EXAMINATION, TESTING, AND EVALUATION OF  
IRRADIATED PRESSURE VESSEL SURVEILLANCE  
SPECIMENS FROM THE MONTICELLO  
NUCLEAR GENERATING PLANT

NORTHERN STATES POWER COMPANY

November 5, 1984

LIST OF CHANGES FOR BCL-585-84-2 REVISION 1

FIGURE 15. CHARPY V-NOTCH IMPACT ENERGY VERSUS TEST TEMPERATURE FOR THE IRRADIATED WELD METAL SPECIMENS FROM THE MONTICELLO 30 DEGREE SURVEILLANCE CAPSULE

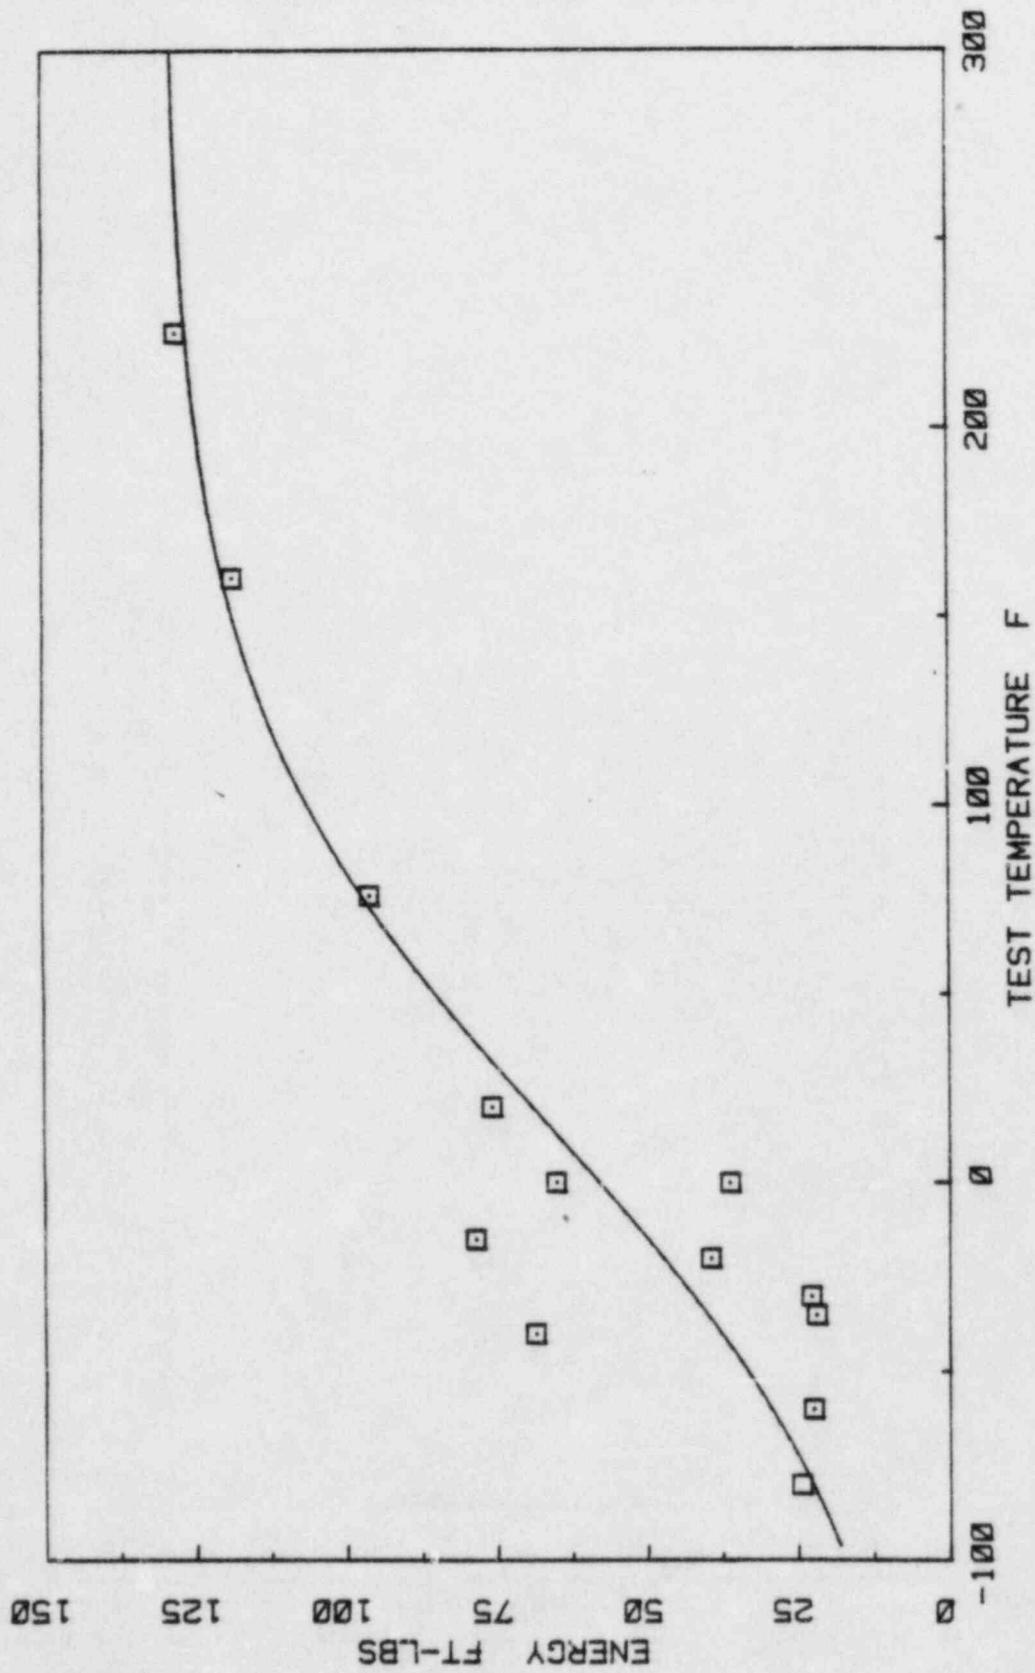
| <u>Page</u>    | <u>Line</u>                       | <u>Changes</u>  |
|----------------|-----------------------------------|---|
| 49             | Figure 15                         | Removed points at - <u>30F (71.3)</u> and <u>300F</u><br>(113.0)  |

FIGURE 16. CHARPY V-NOTCH LATERAL EXPANSION VERSUS TEST TEMPERATURE FOR THE IRRADIATED WELD METAL SPECIMENS FROM THE MONTICELLO 30 DEGREE SURVEILLANCE CAPSULE

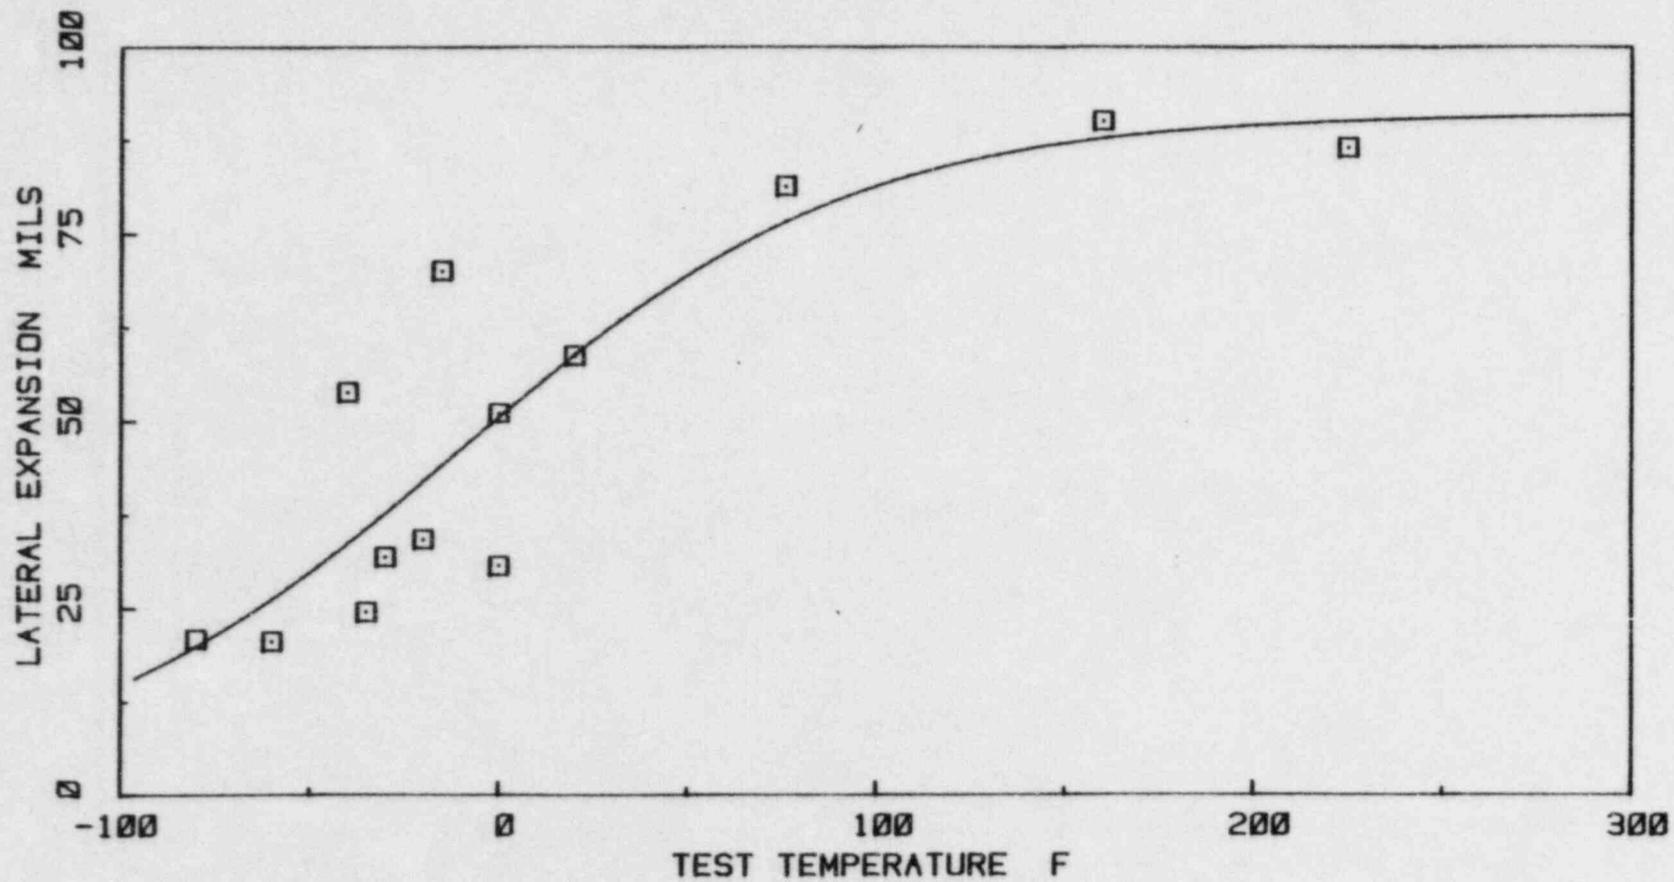
| <u>Page</u>    | <u>Line</u>                       | <u>Changes</u>  |
|----------------|-----------------------------------|---|
| 50             | Figure 16                         | Removed points at -30F (54.0) and 300F (82.0)   |

FIGURE 17. CHARPY V-NOTCH PERCENT DUCTILE SHEAR VERSUS TEST TEMPERATURE FOR THE IRRADIATED WELD METAL SPECIMENS FROM THE MONTICELLO -30 DEGREE SURVEILLANCE CAPSULE

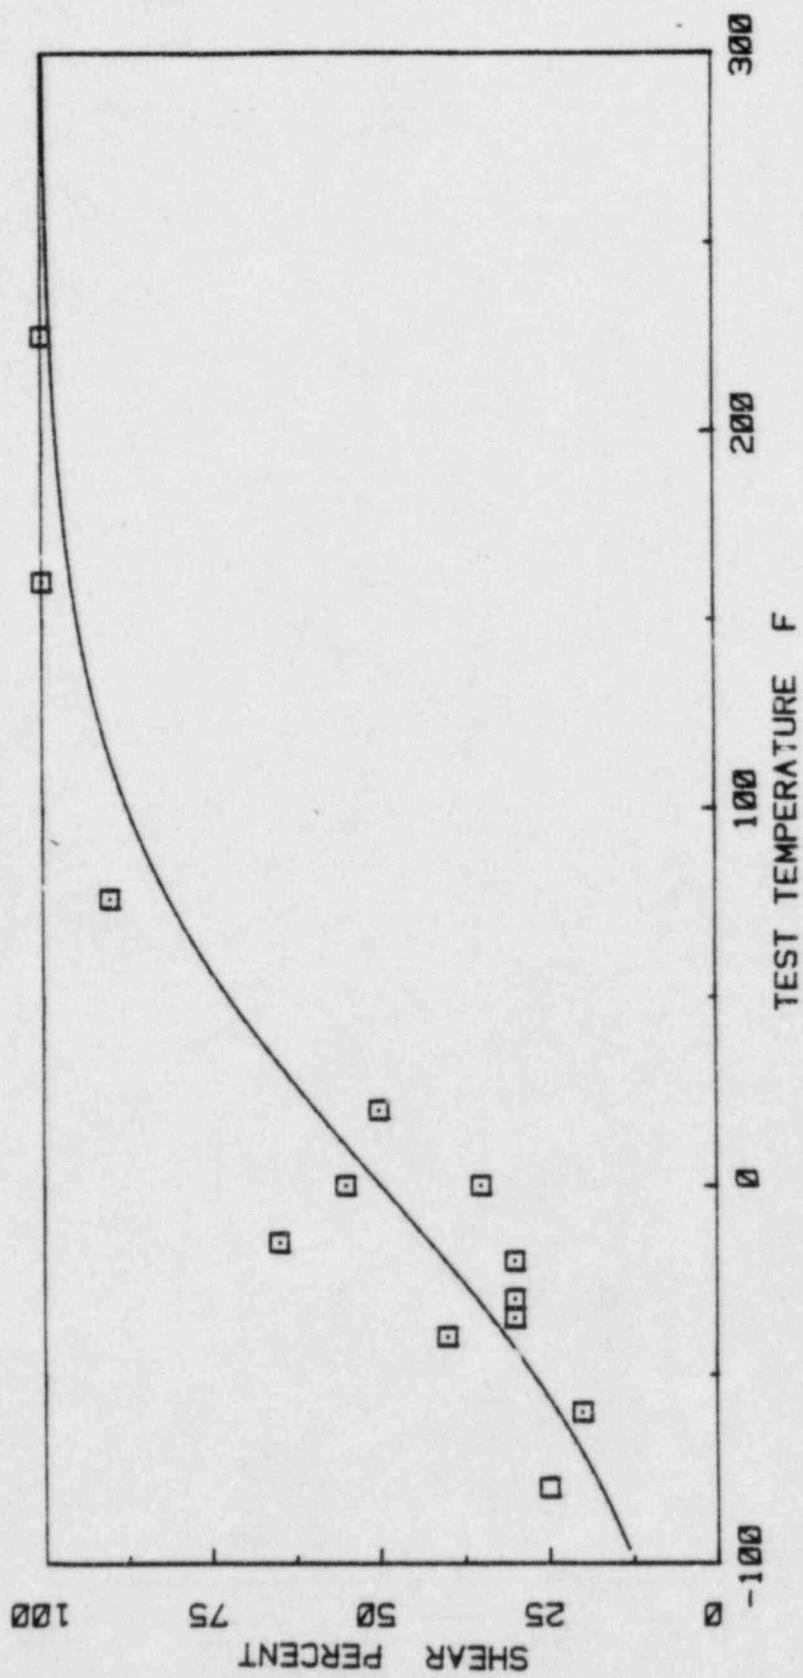
| <u>Page</u>    | <u>Line</u>                       | <u>Changes</u>  |
|----------------|-----------------------------------|---|
| 51             | Figure 17                         | Removed points at -30F (50) and 300F (100)  |

FIGURE 18. CHARPY V-NOTCH IMPACT ENERGY VERSUS TEST TEMPERATURE FOR THE IRRADIATED HAZ METAL SPECIMENS FROM THE MONTICELLO 30 DEGREE SURVEILLANCE CAPSULE

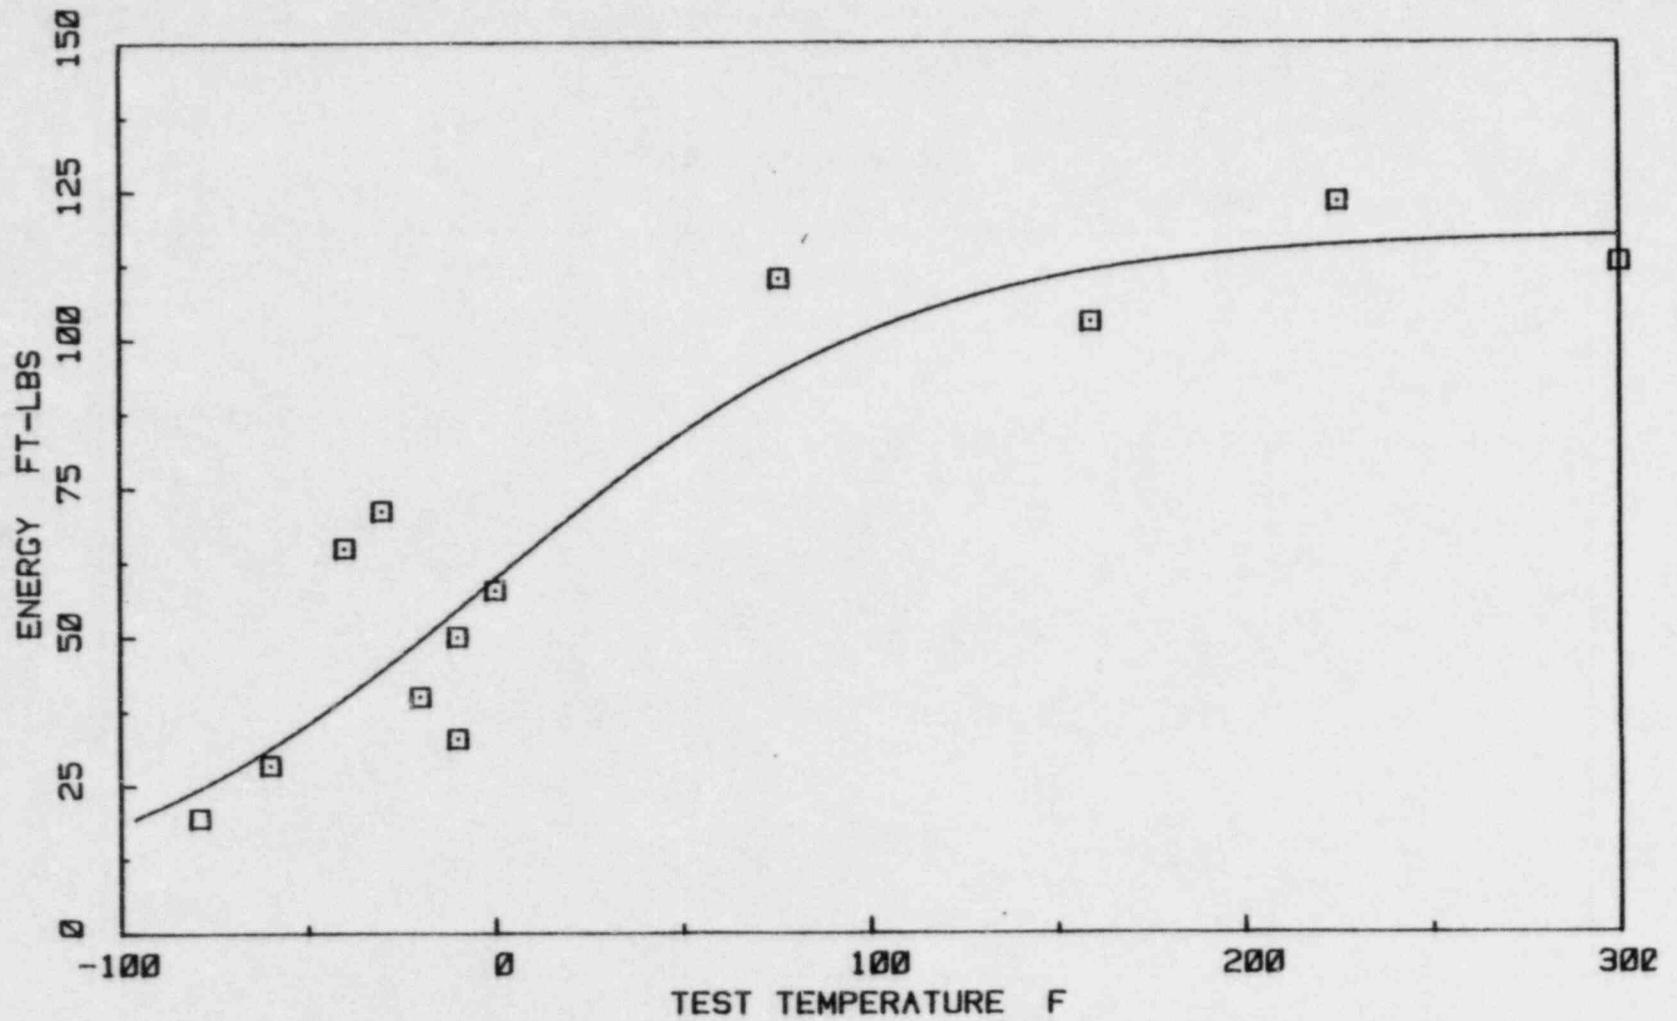
| <u>Page</u>    | <u>Line</u>                       | <u>Changes</u>  |
|----------------|-----------------------------------|---|
| 52             | Figure 18                         | Inserted points at -30F (71.3) and 300F<br>(113.0)  |

FIGURE 19. CHARPY V-NOTCH LATERAL EXPANSION VERSUS TEST TEMPERATURE FOR THE IRRADIATED HAZ METAL SPECIMENS FROM THE MONTICELLO 30 DEGREE SURVEILLANCE CAPSULE

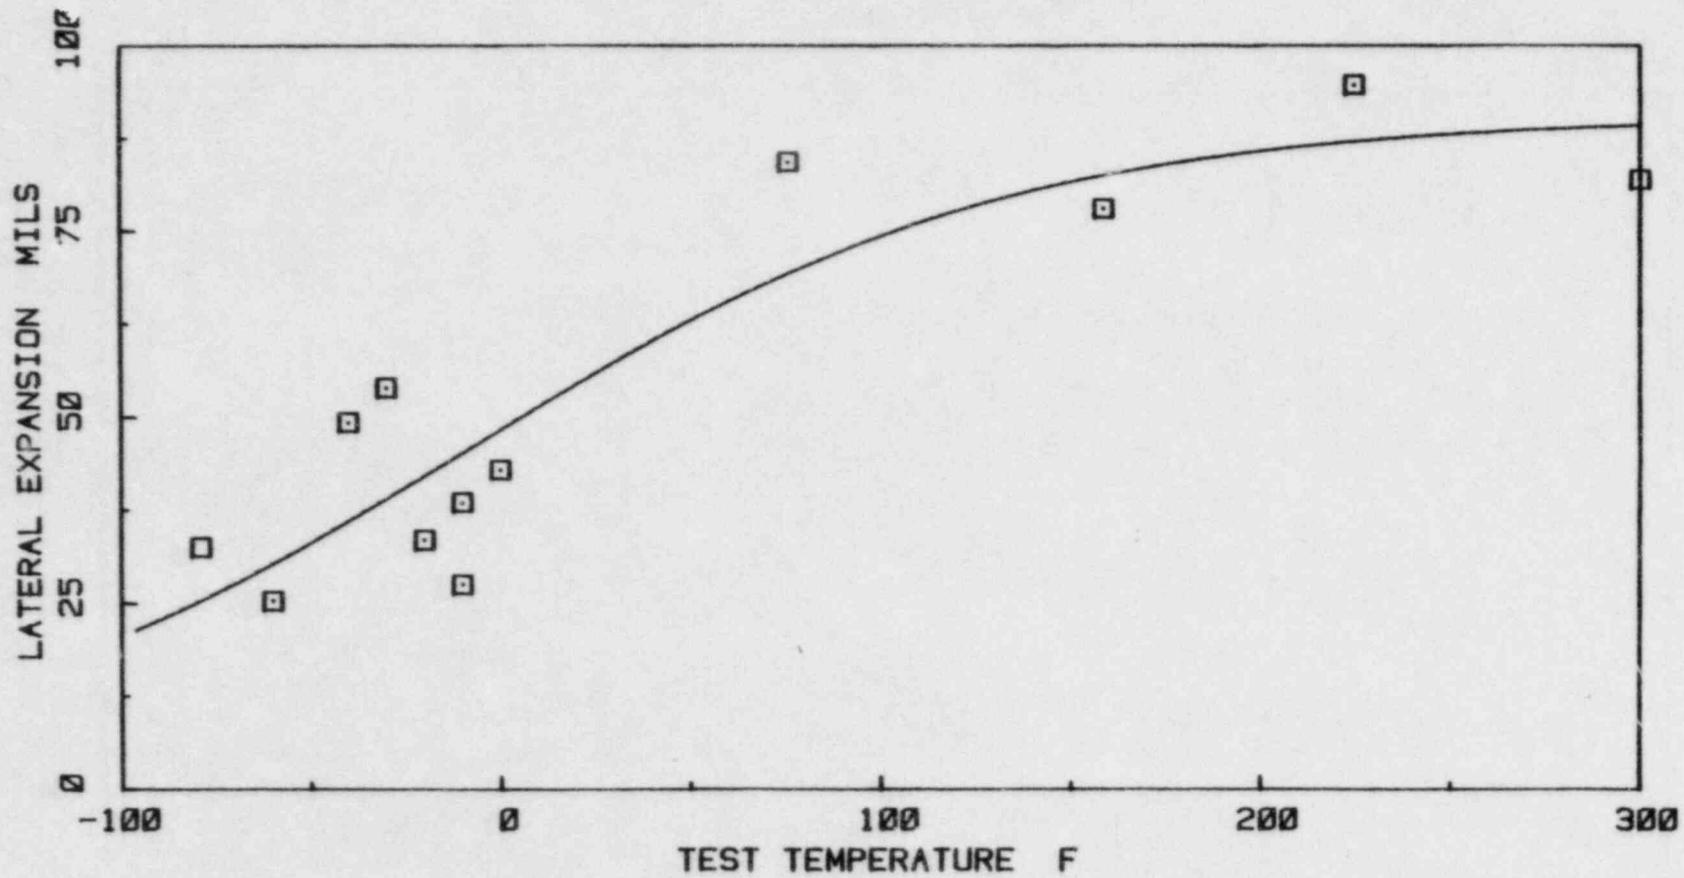
| <u>Page</u>    | <u>Line</u>                       | <u>Changes</u>  |
|----------------|-----------------------------------|---|
| 53             | Figure 19                         | Inserted points at -30F (54.0) and 300F<br>(82.0)   |

FIGURE 20. CHARPY V-NOTCH PERCENT DUCTILE SHEAR VERSUS TEST TEMPERATURE FOR THE IRRADIATED HAZ METAL SPECIMENS FROM THE MONTICELLO 30 DEGREE SURVEILLANCE CAPSULE

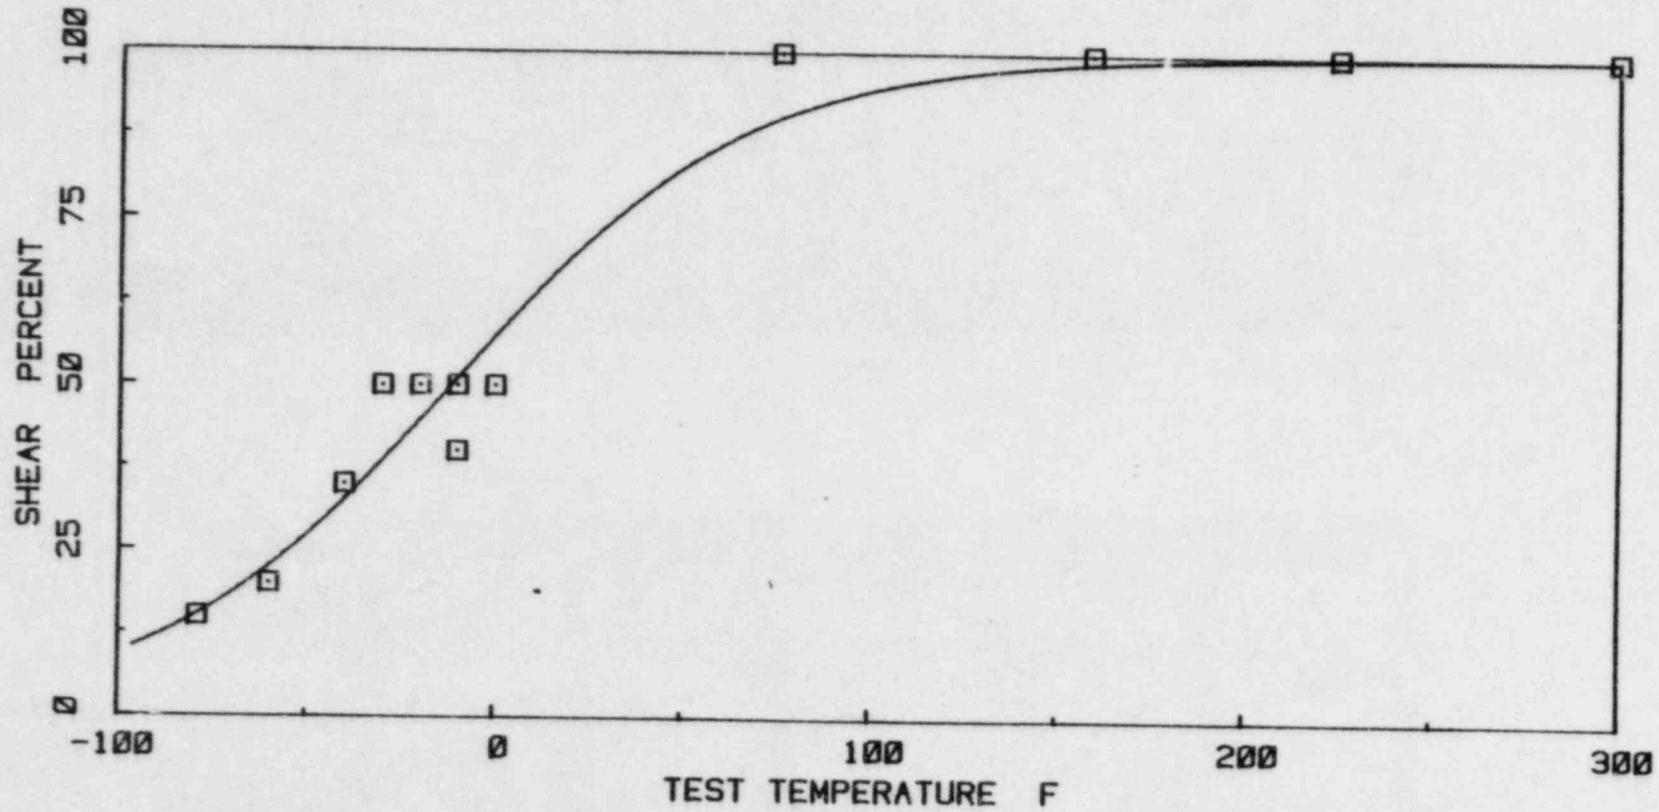
| <u>Page</u>    | <u>Line</u>                       | <u>Changes</u>  |
|----------------|-----------------------------------|---|
| 54             | Figure 20                         | Inserted points at -30F (50) and 300F (100)   |

FIGURE 22. CHARPY IMPACT SPECIMEN FRACTURE SURFACES FOR THE IRRADIATED WELD METAL SPECIMENS FROM THE MONTICELLO 30 DEGREE SURVEILLANCE CAPSULE

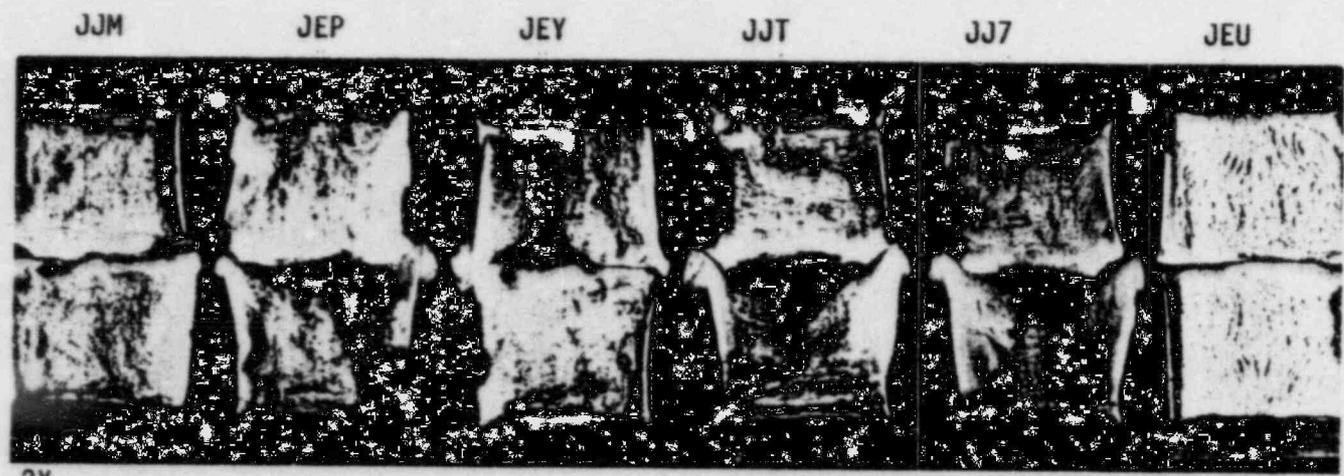
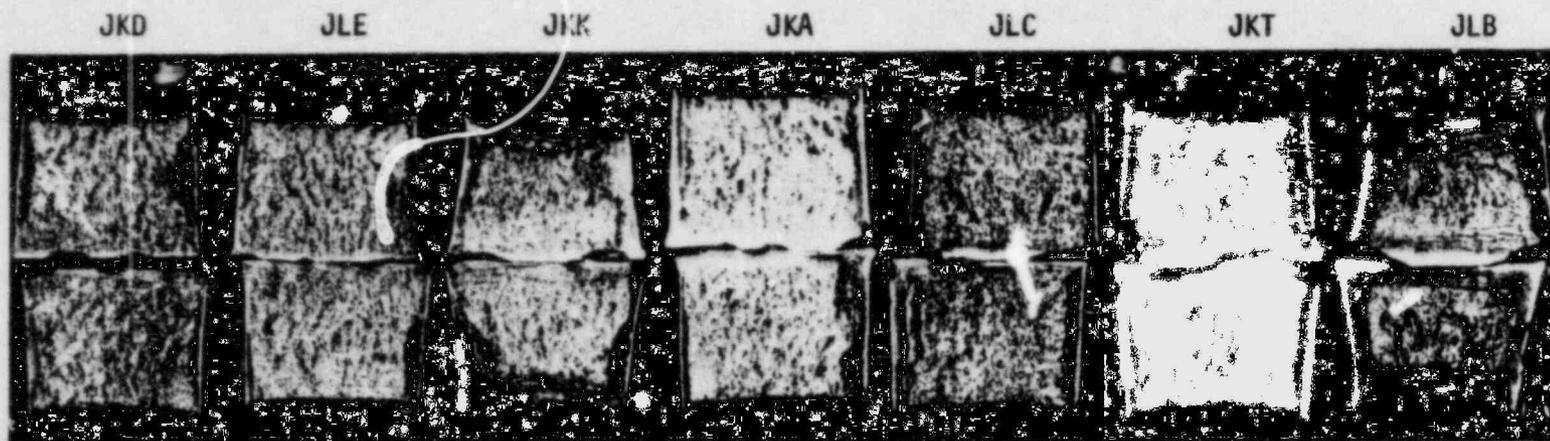
| <u>Page</u>    | <u>Line</u>                       | <u>Changes</u>  |
|----------------|-----------------------------------|---|
| 56             | Figure 22                         | Removed photo of JKA from top row and JKE<br>from bottom row  |

FIGURE 23. CHARPY IMPACT SPECIMEN FRACTURE SURFACES FOR THE IRRADIATED HAZ METAL SPECIMENS FROM THE MONTICELLO 30 DEGREE SURVEILLANCE CAPSULE

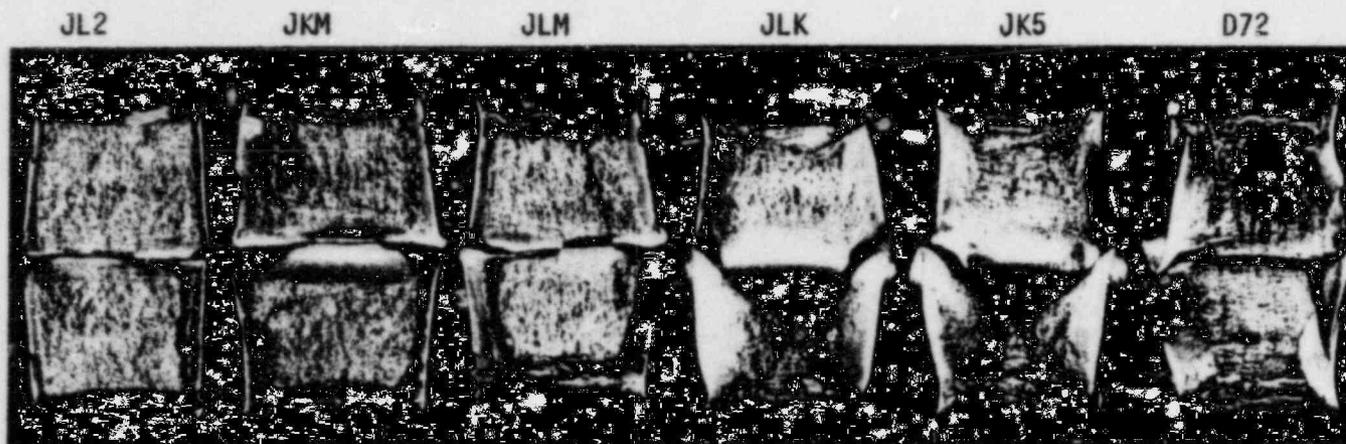
| <u>Page</u>    | <u>Line</u>                       | <u>Changes</u>  |
|----------------|-----------------------------------|---|
| 57             | Figure 23                         | Inserted photo of JKA in top row and <u>JK5</u><br>(typo) in bottom row                                       |
